LOT 12A, TINLEY PARCELS REVISION NEW MEXICO ERNALILLO COUNTY HIGH DESERT ROOFING OFFICE BUILDING Grading & Drainage Plan

Clark Consulting Engineers Tele: (505) 281-2444 REVISION DATE 2/1/02 As. built Transp. /Drng

# CALCULATIONS REVISED, AS-BUILT CALCS.

HIGH DESERT ROOFING OFFICE BUILDING Grading, Drainage & Transpo Plan

19 Ryan Road Edgewood, New Mexico 87015 Fax: (505) 281-2444 LOT 12A, TINLEY PARCELS BERNALILLO COUNTY NEW MEXICO HIGH DESERT ROOFING OFFICE BUILDING Grading, Drainage & Transpo Plan

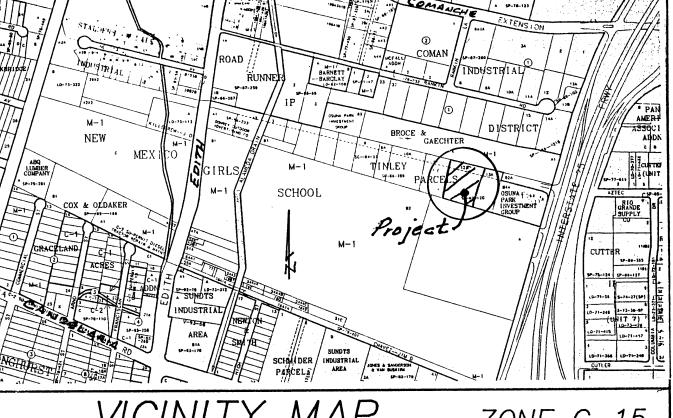
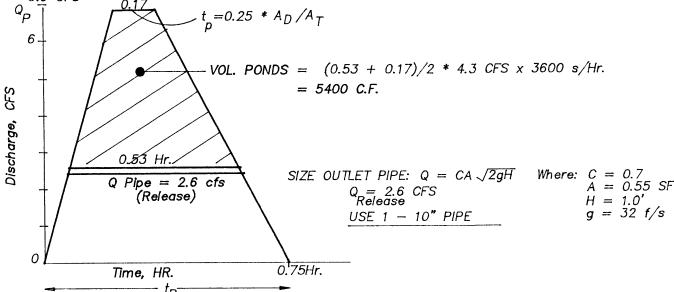
BUILT R.R. TIE WALL, 2.5' H.

IN-LIEU OF 2.5' CUT SLOPE

BUILT -INSTALL- 1—18'x10" DIA. CMP CULVERT Inv.(SE)=56.5, Inv.(NW)=54.0

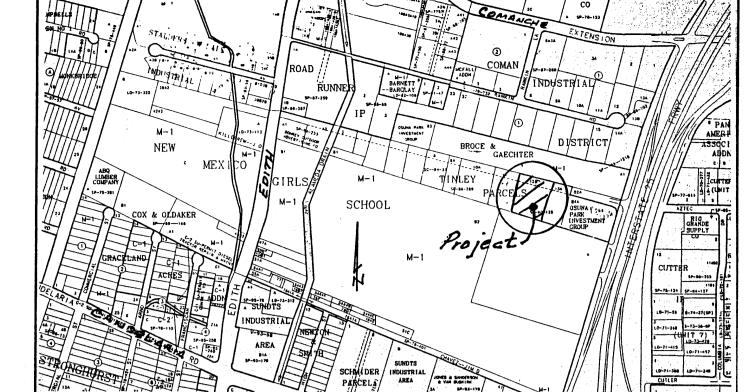
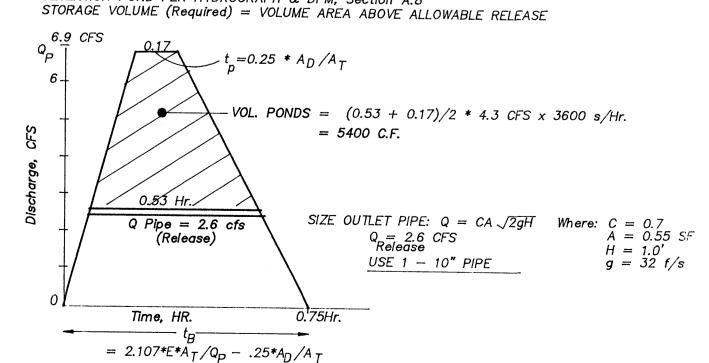
## CALCULATIONS REVISED, AS-BUILT CALCS.

BUILT -INSTALL- 1—18'x10" DIA. CMP CULVERT Inv.(SE)=56.5, Inv.(NW)=54.0 ACCESS Exist. Gravel Lined Swale 🗞 36"-CMP-SD-----NOTE: SWALE AND STORM DRAIN OUT FALL REST AT THE ALAMEDA DRAIN,
VIA 2-DOUBLE D CATCH BASINS (1425'±WEST OF PROJECT) LANDSCAP \BUILT NSTALL 1—12° € CNN CULVERT, 43 L RETENTION POND= 600 CF-Area<sub>57</sub> Contour = 1077 SFX 1' Depth = 600 CF NEW ASPHALT NEW CHAINLINK FENCI **ASPHALT** STRUCTURE SETBACK LINE, TYP. 2-HC SIGNS WHITE /BLUE-OFFICE / WAREHOUSE LOT 12A (1.69 ACRES) | FIN. FLOOR ELEV. = AROUND PROPERTY BLOCK OUT PARKING STALLS ASPHALT 12'x12' Conc. Cont'm't. Structure **ASPHALT** EXISTING CRUSHED ASPHALT LINED CUT SLOPE CALCULATE GRADED DETENTION PONDS: PROJECT DATA TRACT A NEW MEXICO GIRLS SCHOOL X 2' Depth = 2540 CF Area<sub>57</sub> Contour = 826 SF -Area 56 Contour = 587 SF x 1' Depth = 706 CF LEGAL DESCRIPTION

BUILT R.R. TIE WALL, 2.5' H. IN-LIEU OF 2.5' CUT SLOPE EXIST. CHAINLINK FENCE
